E.F. MOYA OFFICE BUILDING
1020, 1024, 1028 SUSAN BLVD. ALBUQUERQUE, N.M.

OVERALL DEVELOPMENT PLAN (BY 11/15/81)
SCALE: 1"=20'-0"
PLAN NO. 2-75-110 APPROVED 11-15-80

R. F. MOYA OFFICE BUILDING
1080, 1084, 1088 E. FRANK BLVD. N.E. ALBUQUERQUE, N.M.

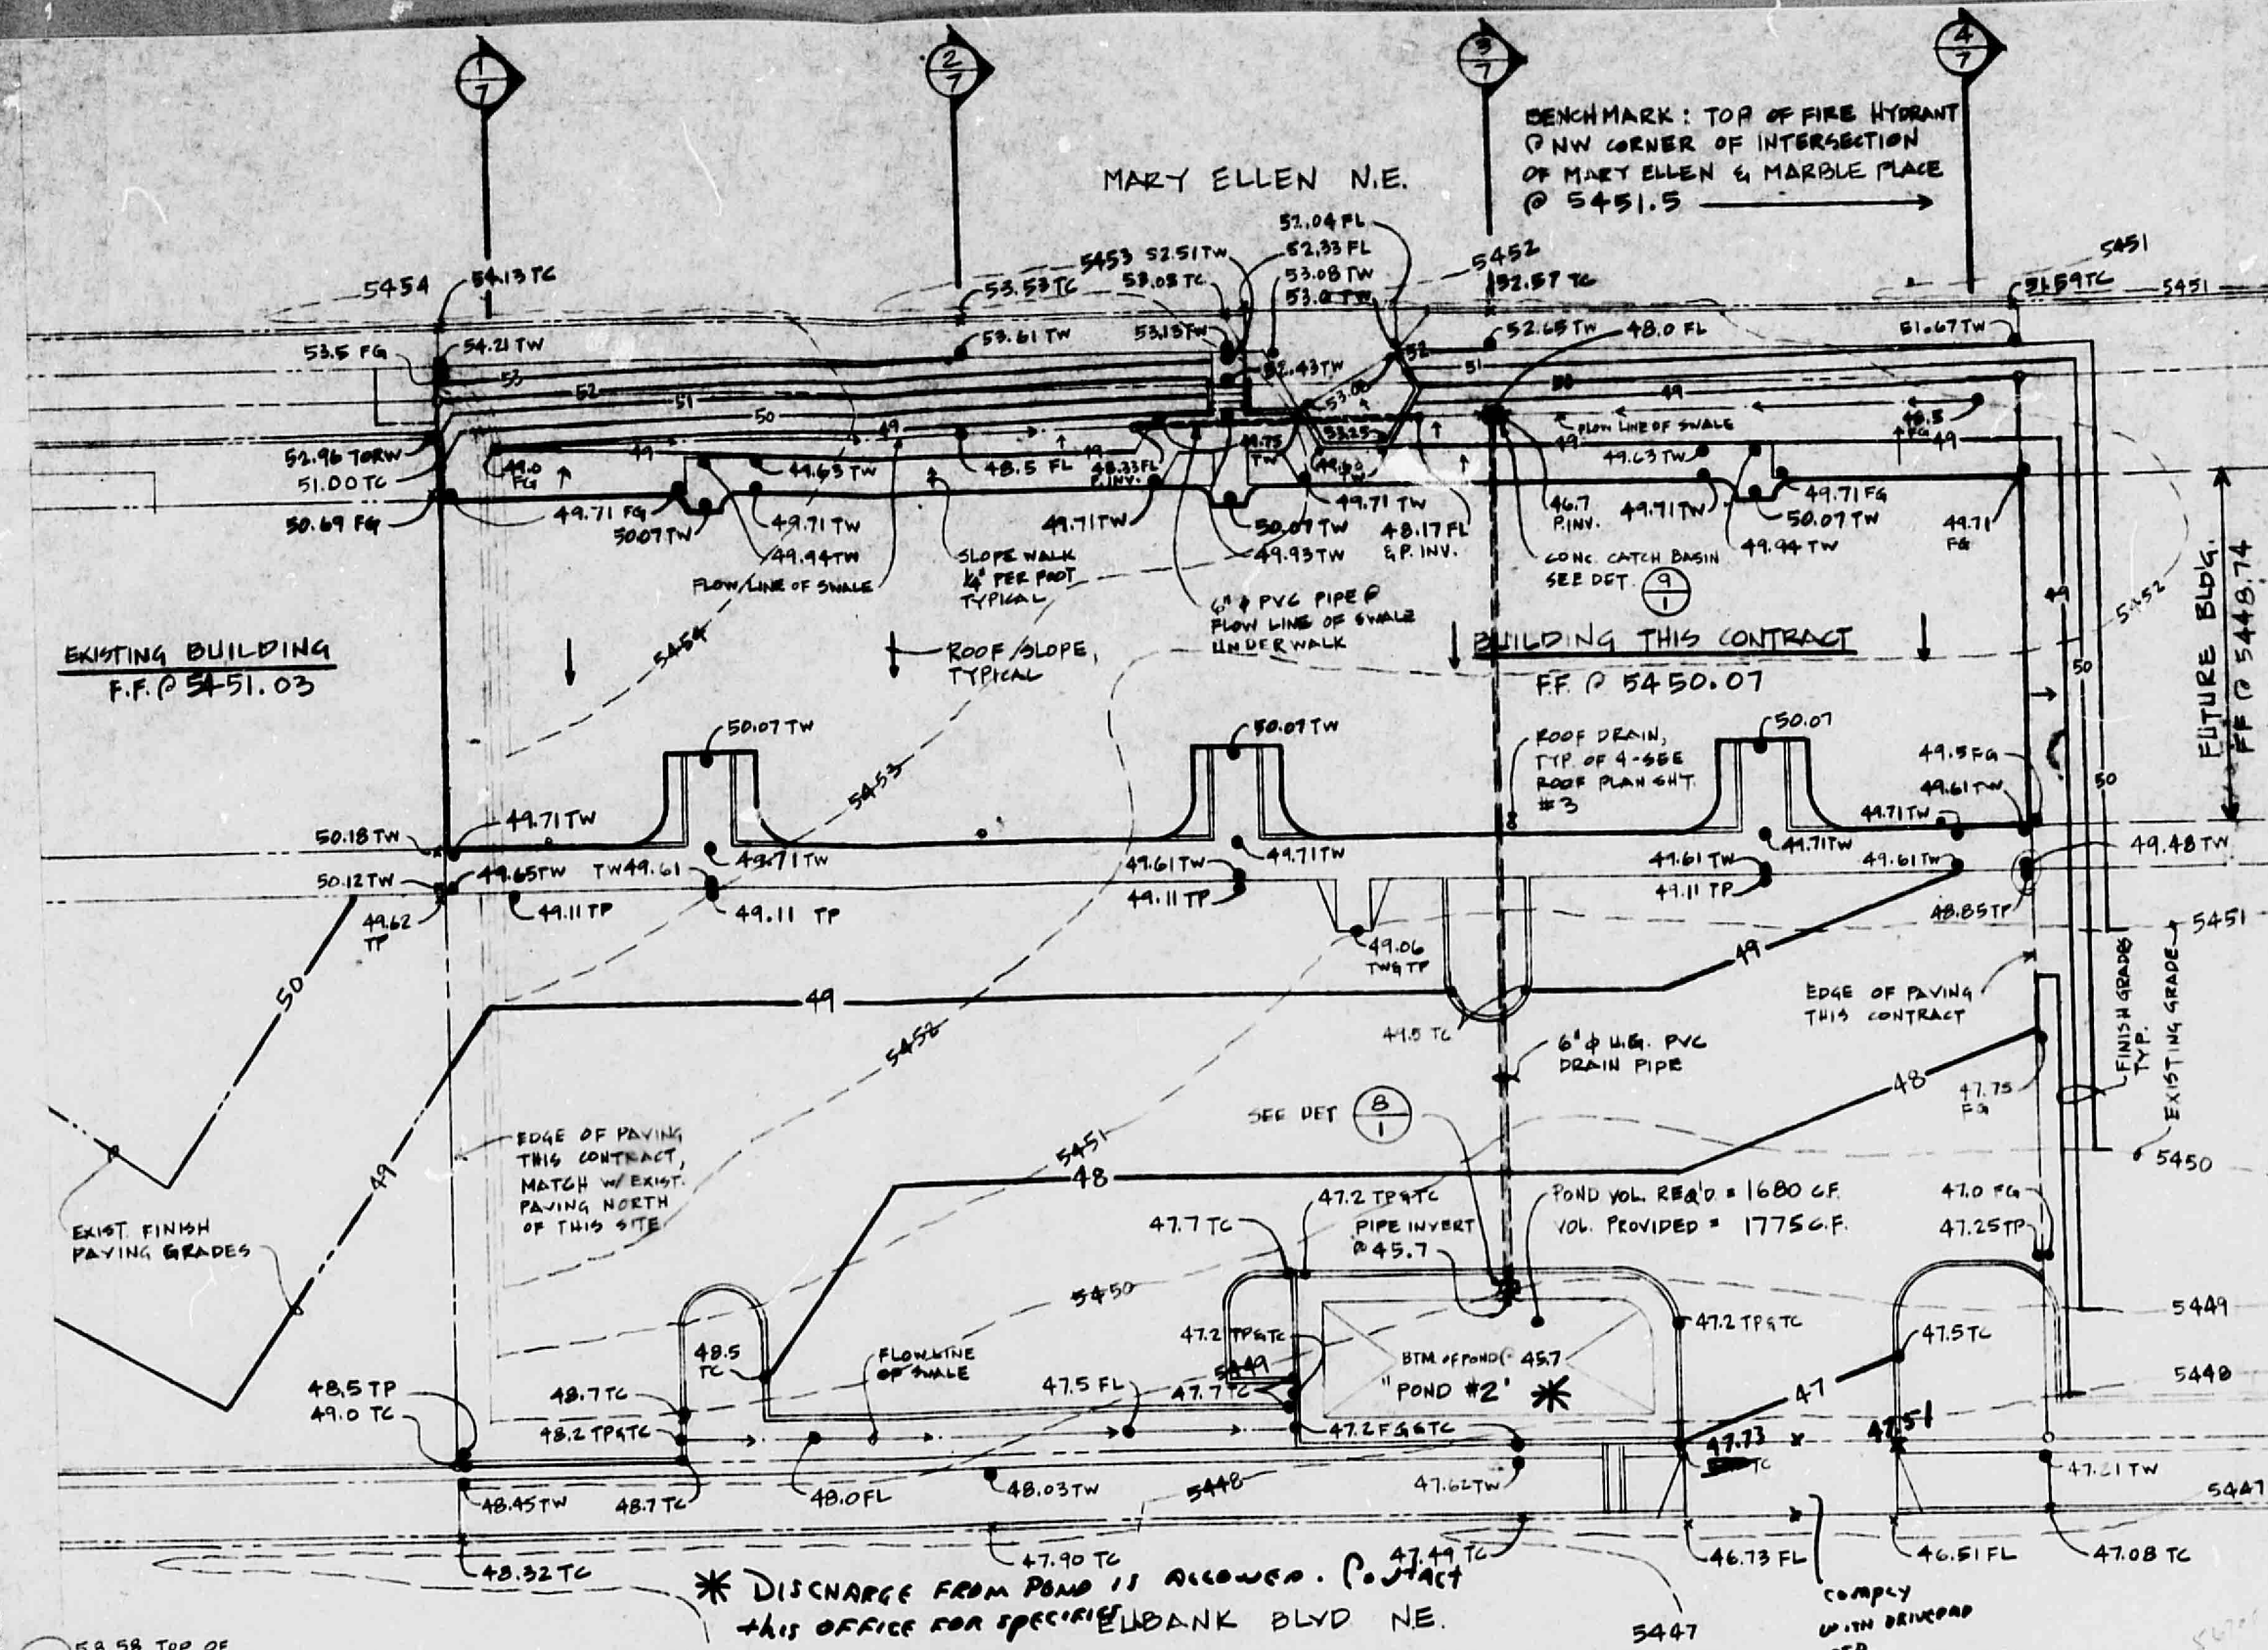
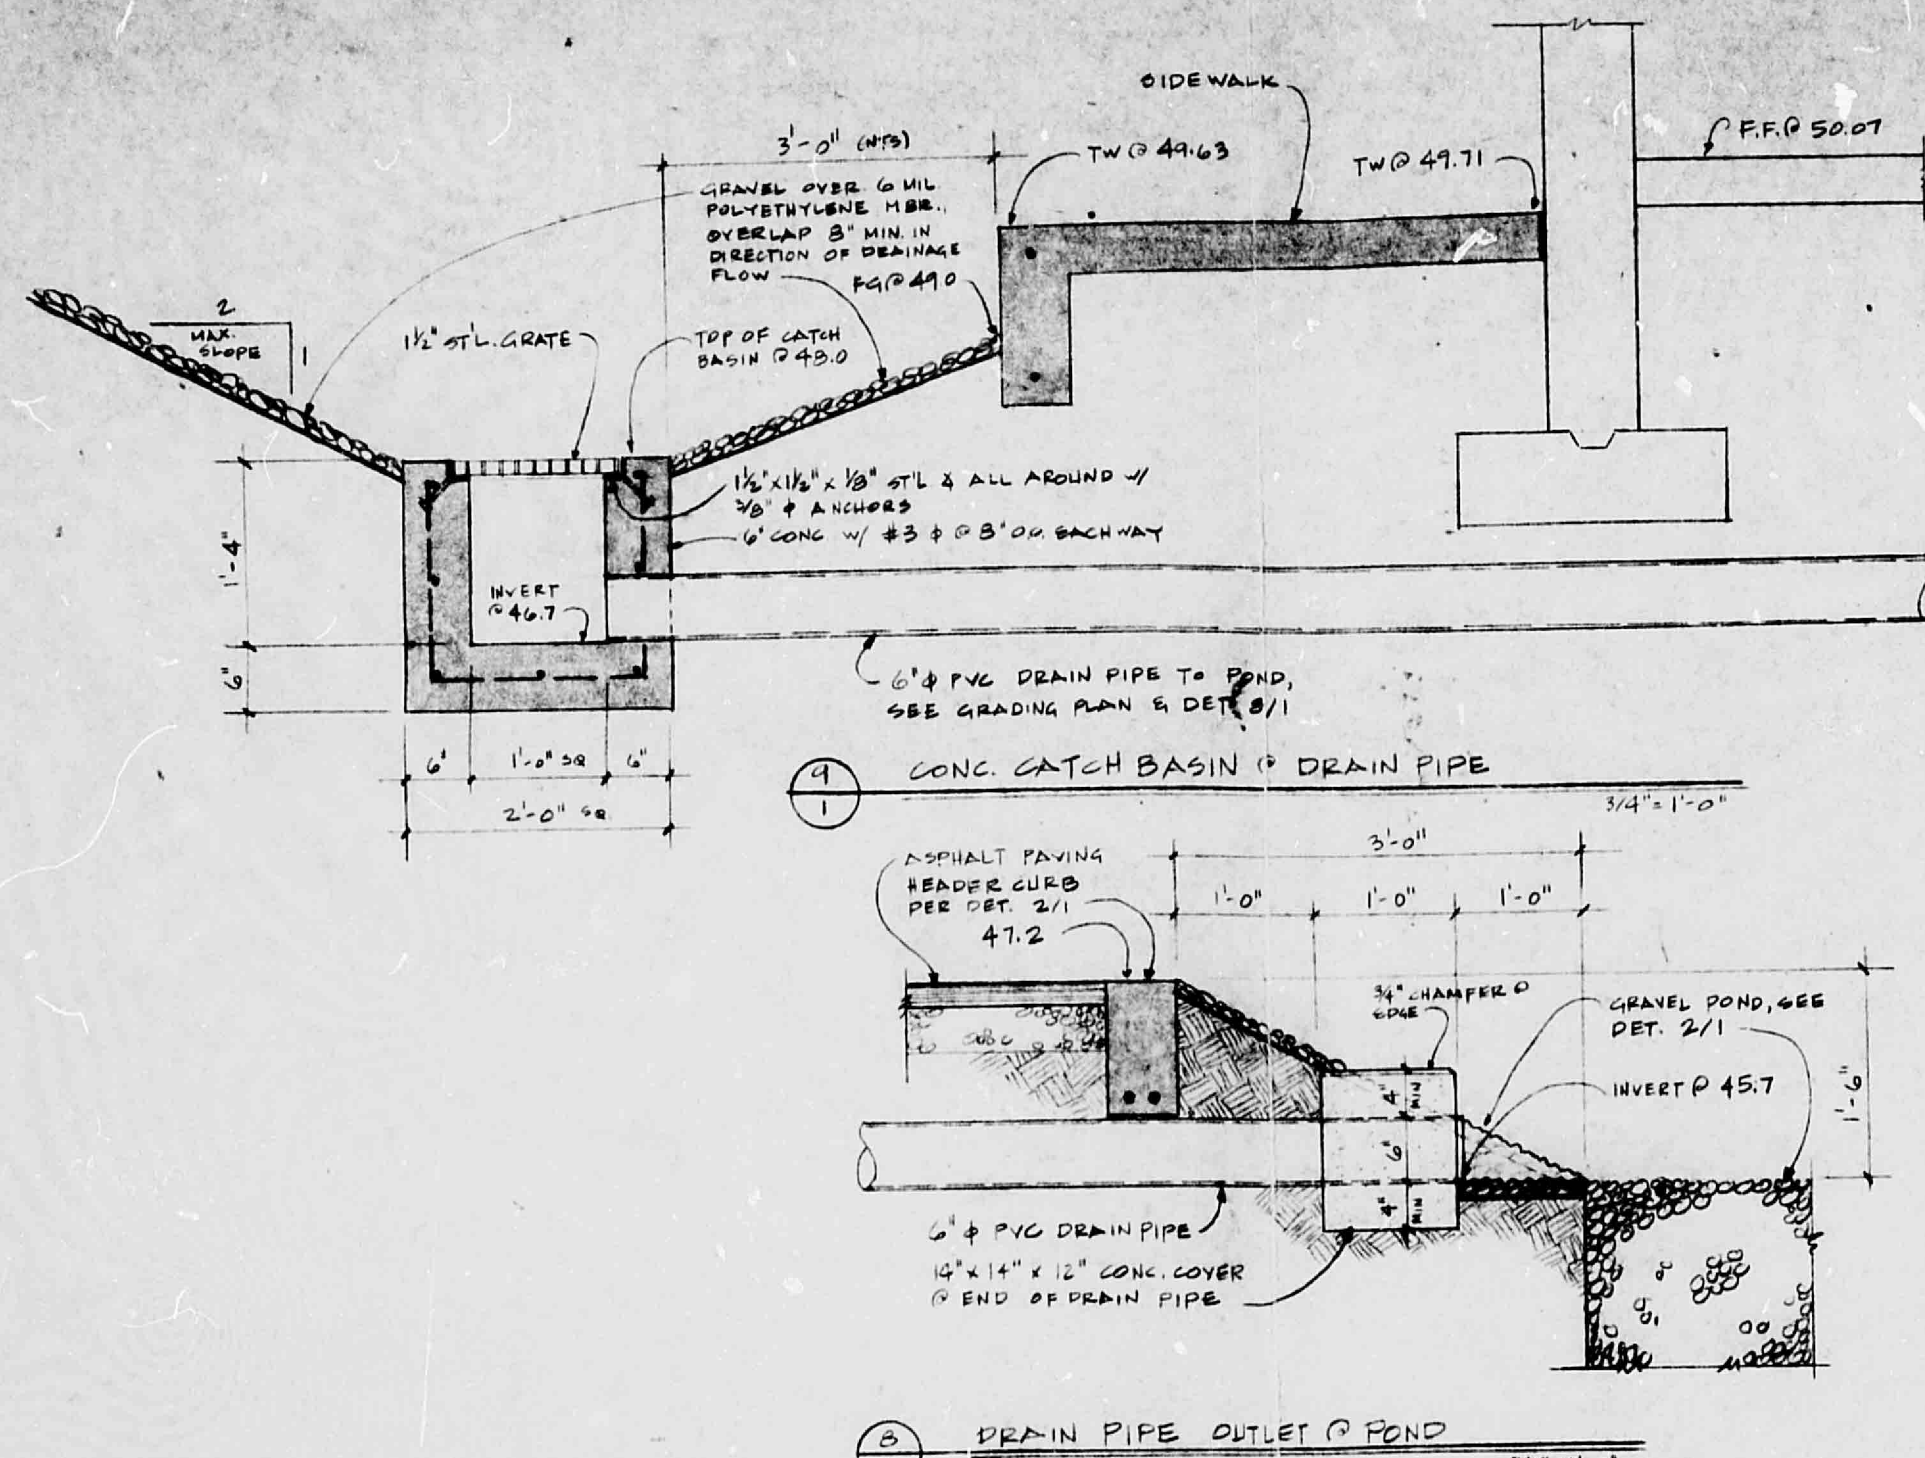
PROTECTION
DISCUSSED WITH Tom Fletcher
OF ART DEKKER OFFICE. Tom will recommend
PIPE BE ENCASED IN THE AREA OF THE PUMPING.
Jgh 6-1-11

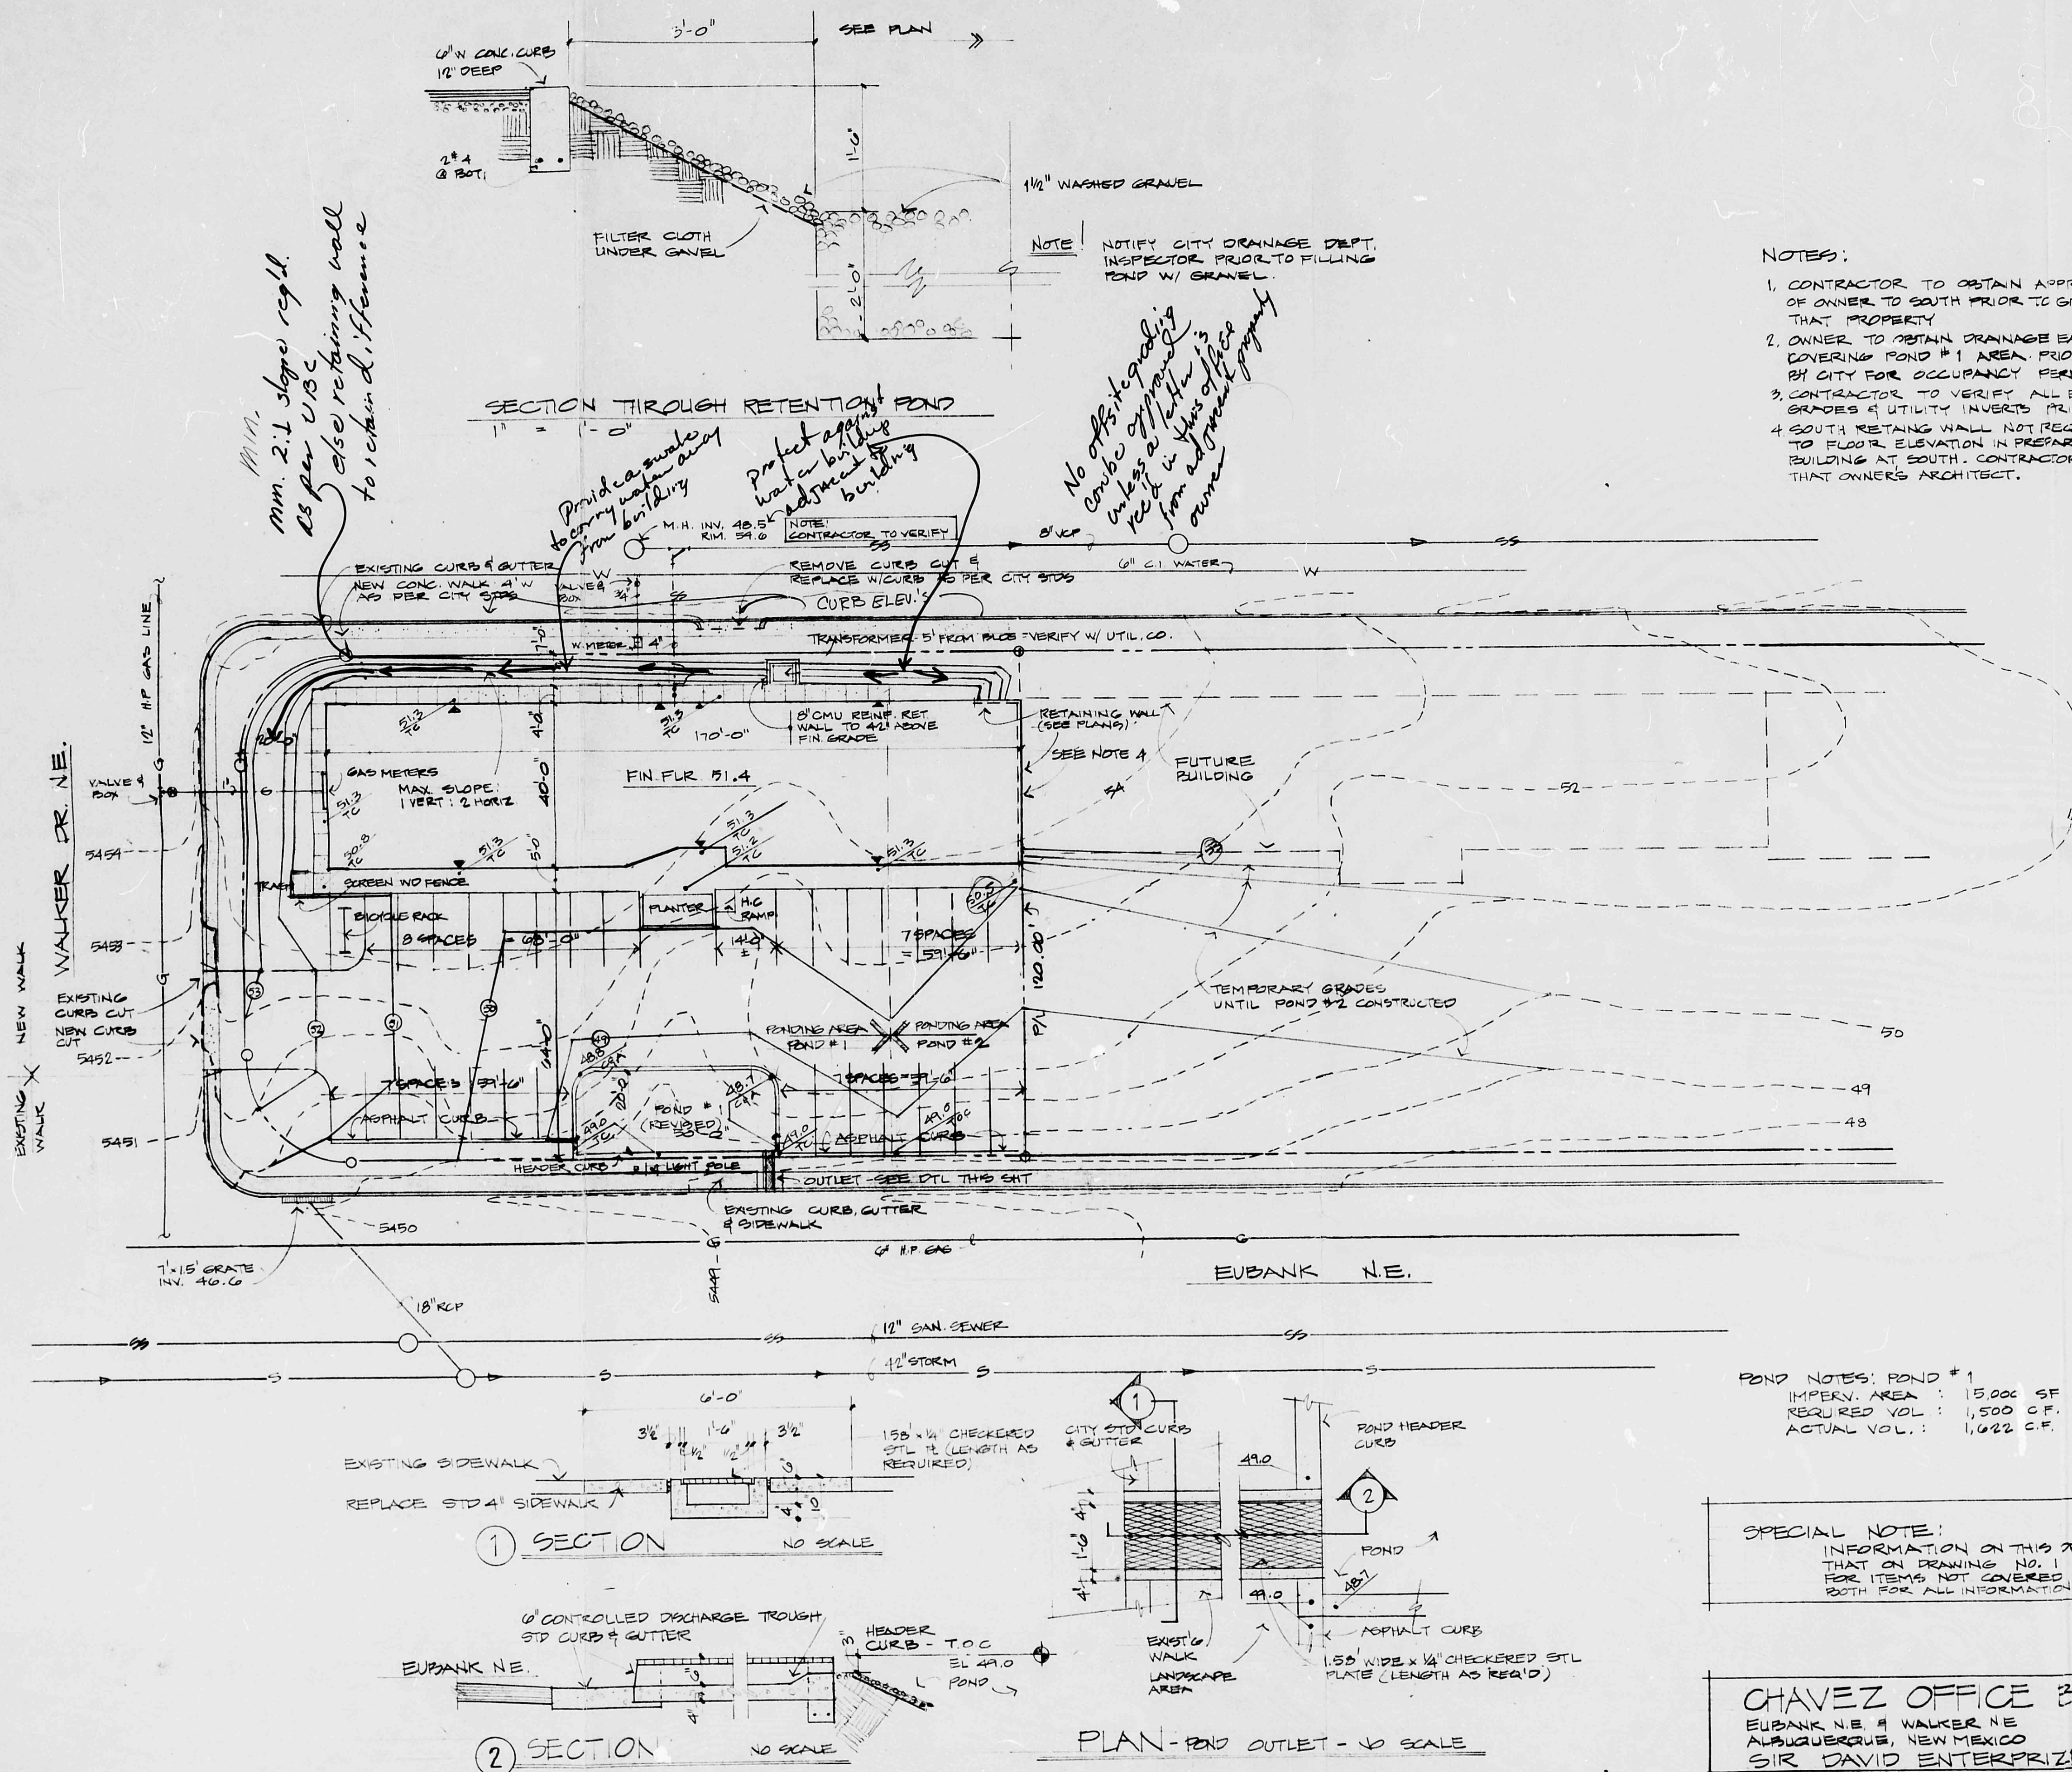
mm. 2:1 slopes req'd.
as per UBC
also retaining wall
to chain d. fence

Provide a walkway
to carry water away
from building
perfect against
wall a building
adjacent to
building

No offset grading
curbs opposite
retaining wall is
from adjacent property
owner
